From: [REDACTED]
Sent: Wednesday, 20 December 2023 11:39 AM
To: TPC Enquiry
Subject: Stadium update
Attachments: Drone settings.jpg; Mac Point drone.jpg; 2 Stadium to scale.JPG

DRONE HEIGHT SURVEY – SULIVANS COVE OCTOBER 2023

PROPOSED HOBART STADIUM TO SCALE* (UNROOFED) – FORM TO BE DECIDED

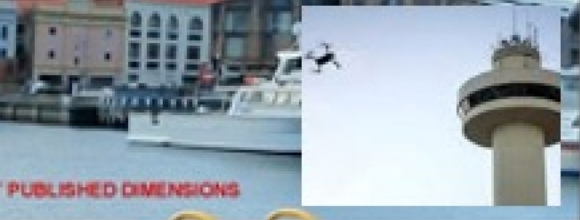
These drones were privately commissioned and confirm the impact of the state government's own published dimensions (for the proposed stadium) when viewed at pedestrian eye-level from the most popular vantage point on Hobart's waterfront. The government refuses to show any CGI from this location.

The stadium image is obviously representational, but clearly conveys the indisputable overbearing such bulk would inflict upon the precious Hunter Street heritage facades. All of the honourable members of the panel must agree the chosen site (forced upon our hoodwinked Premier by the AFL) is completely out of scale in both height and diameter. Importantly, the government's published dimensions **exclude** the mandatory structural engineering required for a **roofed** stadium which will add even greater (skeletal) height to the outer form.
